**U.S. DEPARTMENT OF ENERGY  
OFFICE OF CIVILIAN RADIOACTIVE WASTE MANAGEMENT**

**NUCLEAR WASTE TECHNICAL REVIEW BOARD  
FULL BOARD MEETING**

**SUBJECT: ESF CHANGES UNDER CONSIDERATION**

# **Exploratory Studies Facility (ESF) Changes Under Consideration June 30, 1993**

# Enhanced ESF Layout - Topopah Spring Level

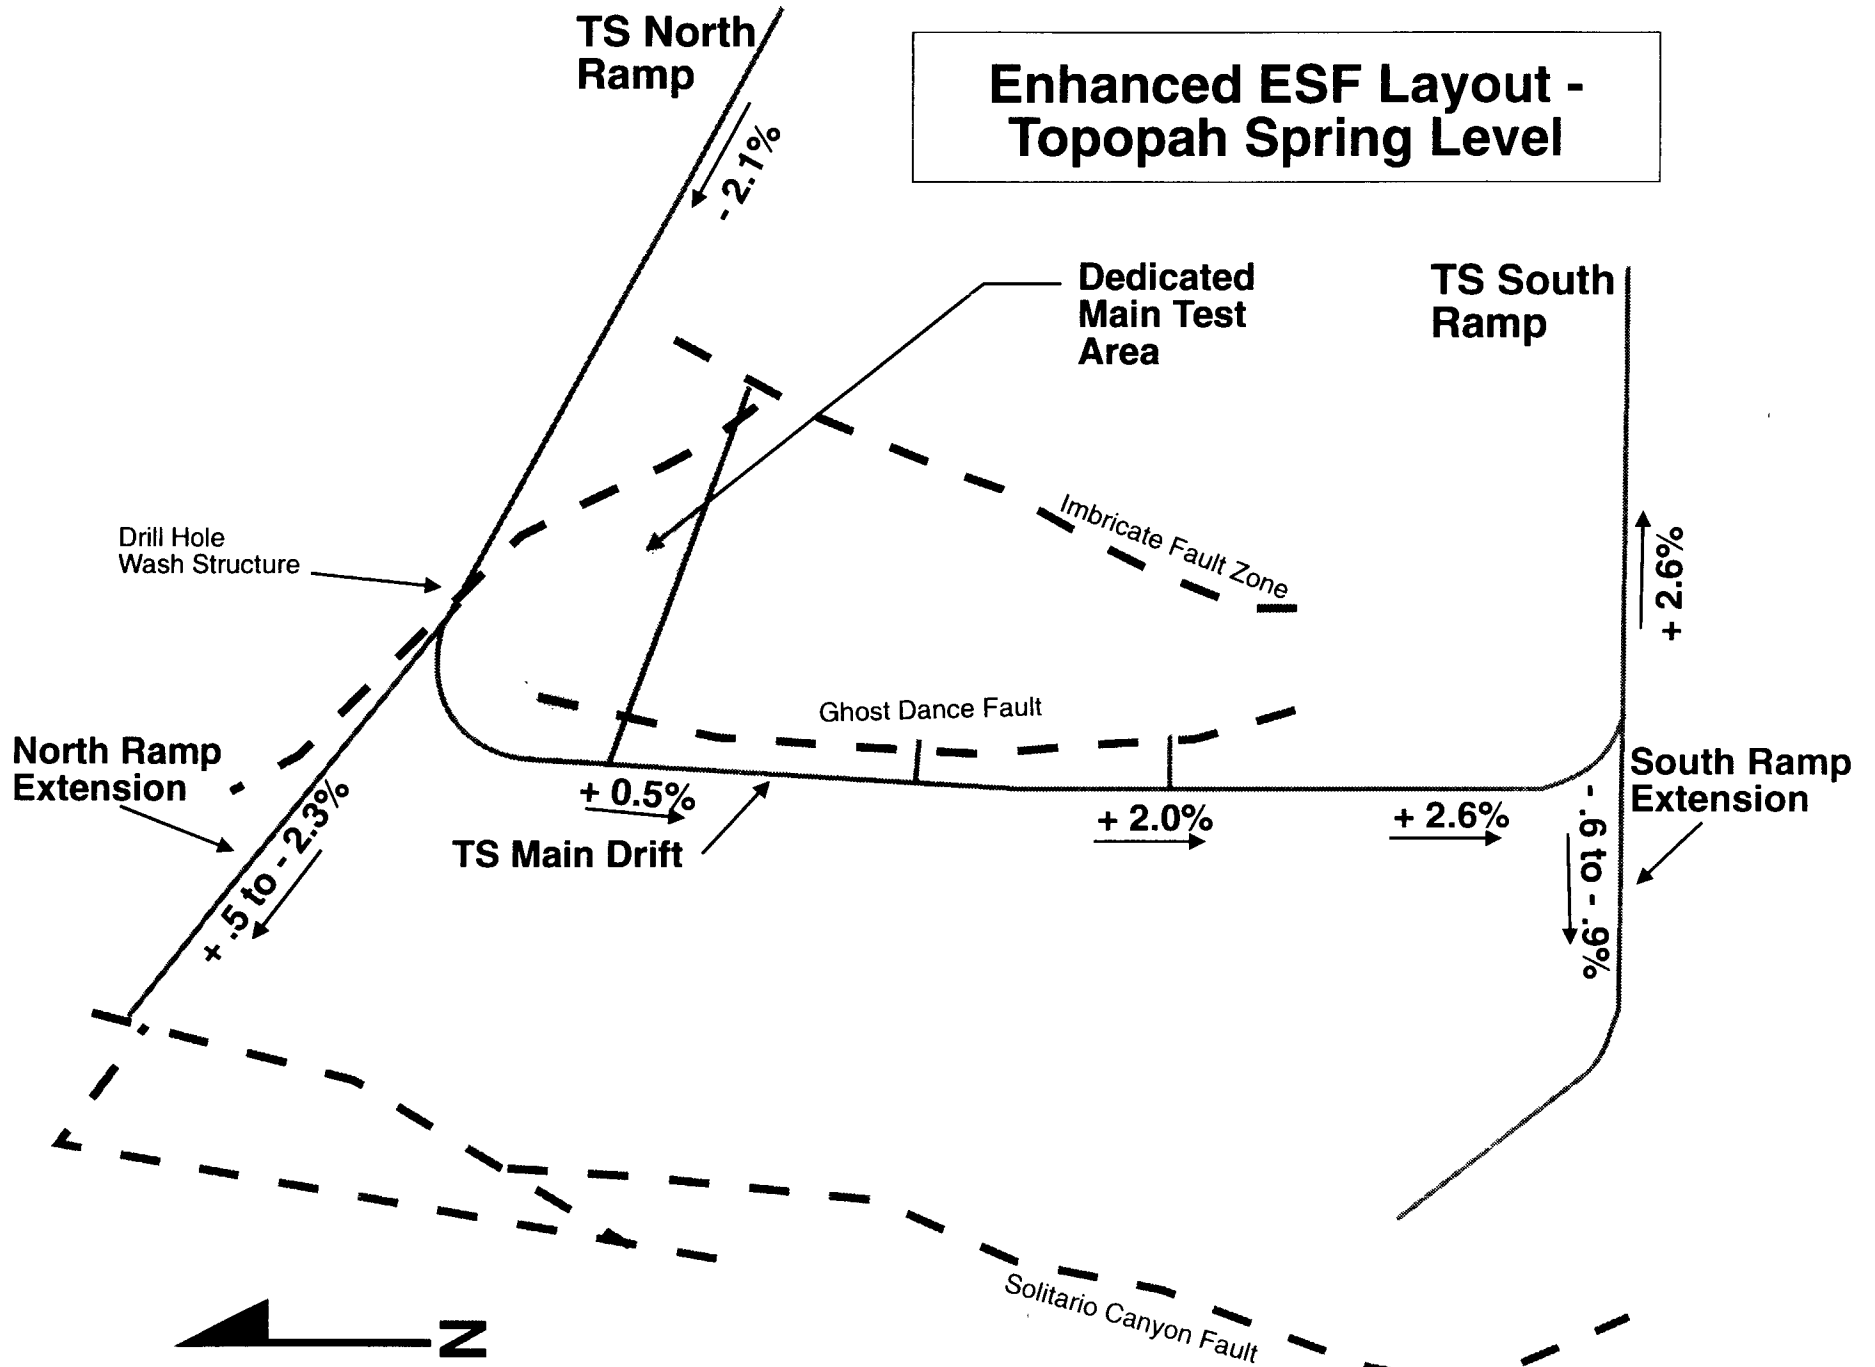
- Maintains the portal location and horizontal direction of the North Ramp**
- Results in having no grade in excess of 2.7% in the North Ramp, Main Topopah Spring Level (TSL) drift, and South Ramp**
- Maintains the full scope of site suitability and characterization testing provided by current ESF design (Option 30) and significantly enhances the characterization of the Ghost Dance fault without affecting repository layout flexibility**

- **Preserve repository design flexibility to a much greater degree than the current configuration, including concepts which increase the distance from emplacement drifts to the water table**
- **Better accommodates repository layouts having flat emplacement drifts and layouts that seek to avoid having emplacement drifts cross the Ghost Dance Fault**

# Enhanced ESF Layout - TSw2 and Calico Hills Drifting

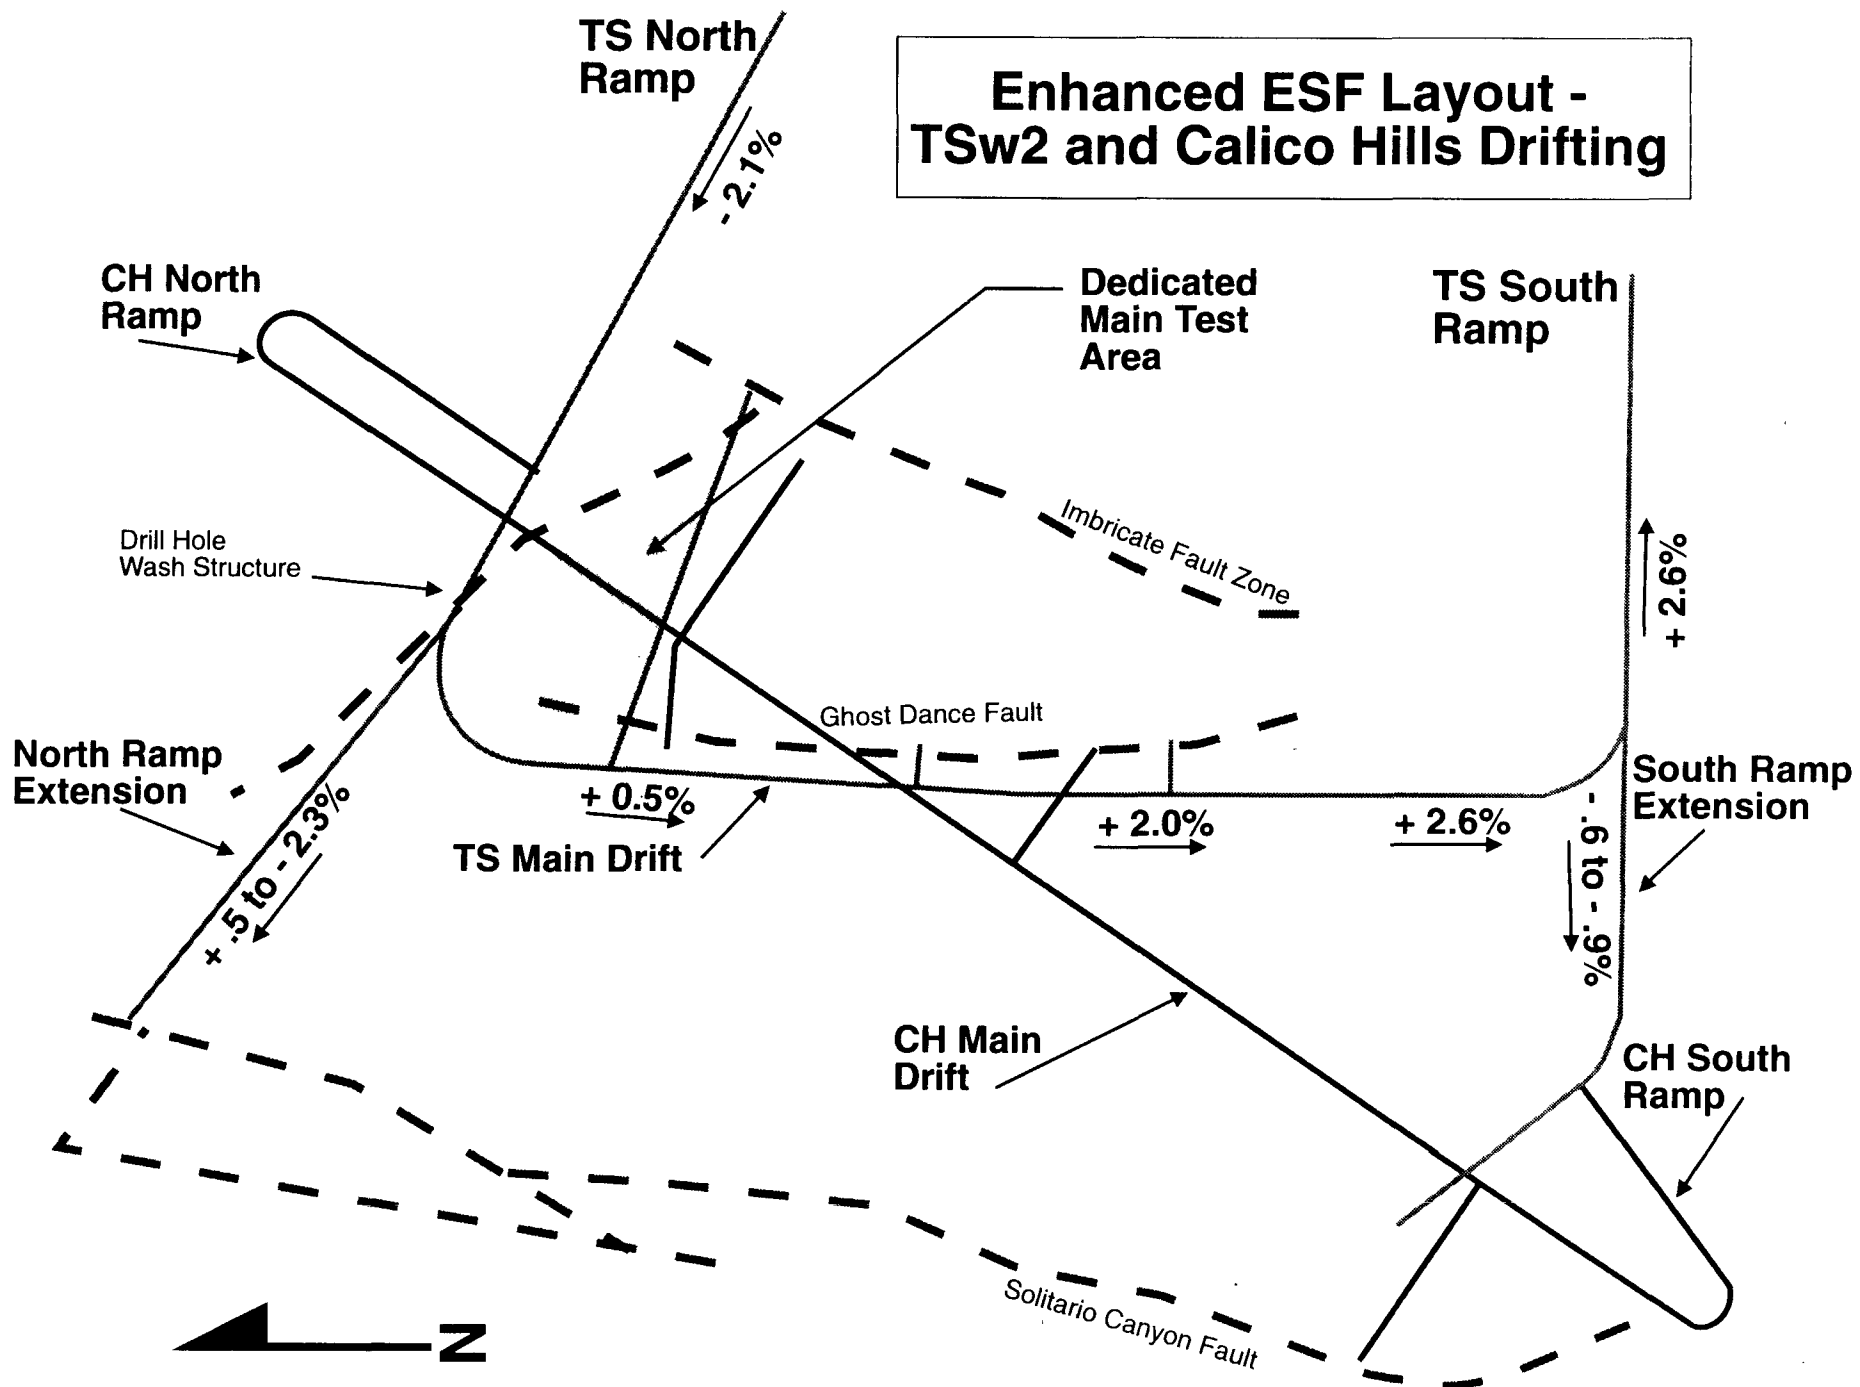
- **Enhances site characterization ability**
  - **Multiple Ghost Dance Fault crossings can be made with relative ease**
  - **Two Solitario Canyon Fault crossings are planned instead of one**
  - **Ramp extensions give a good look at a large percentage of the vertical extent of the TSw2 interval**

# **Why Re-Evaluate North Portal Entrance Design?**

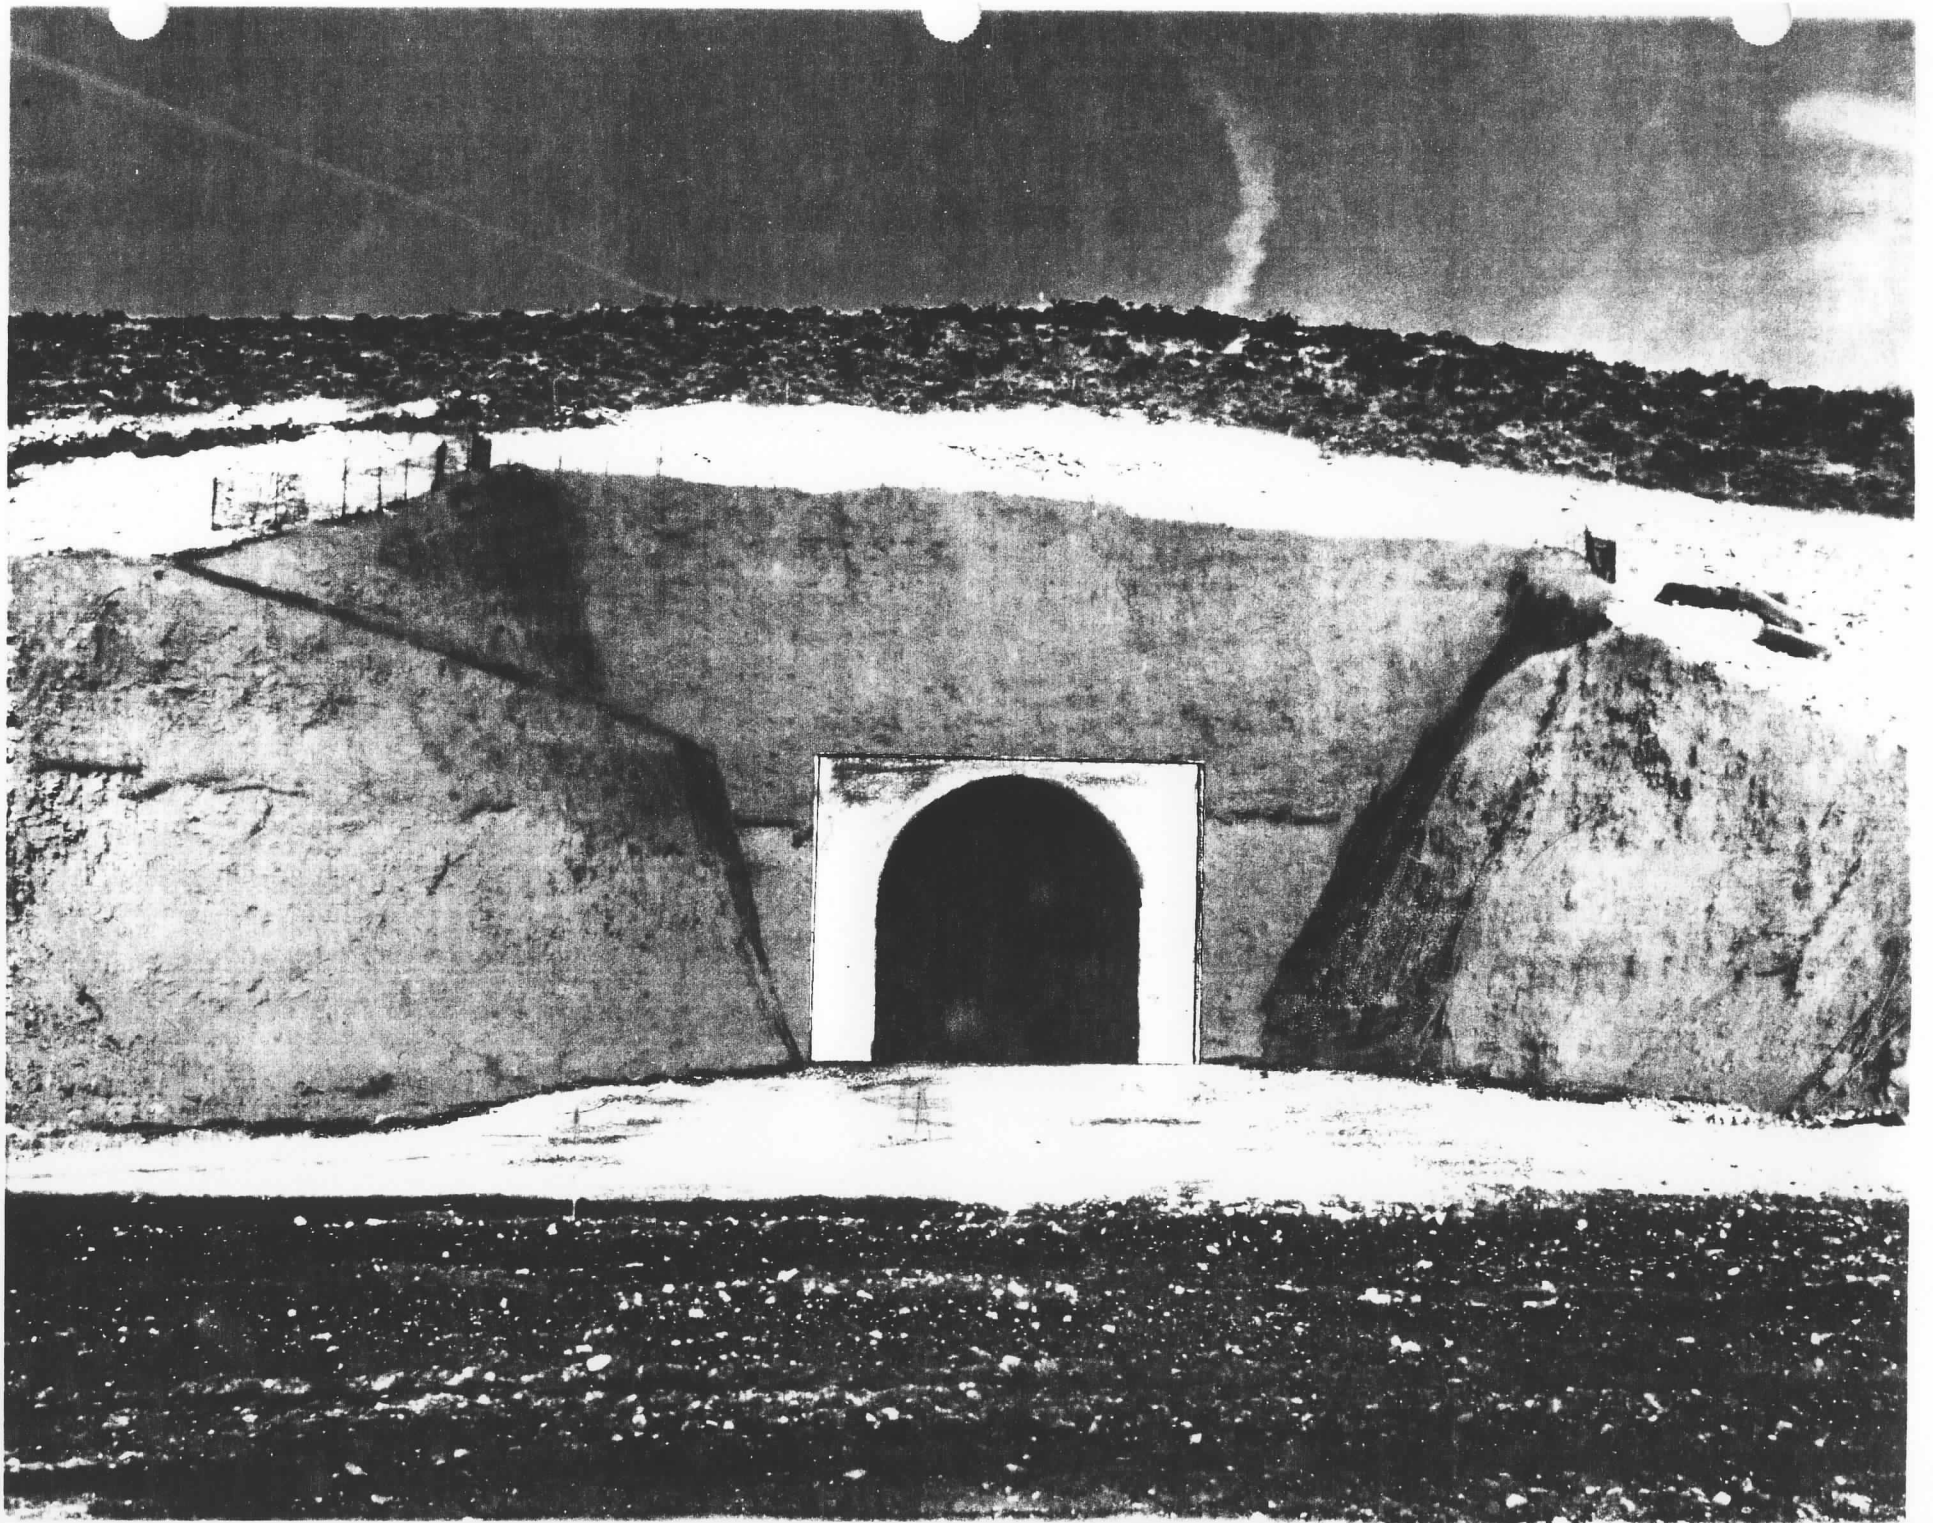
- **Design process is inherently interactive and subject to re-evaluation**
- **Opportunity to use less costly, but just as safe solution**
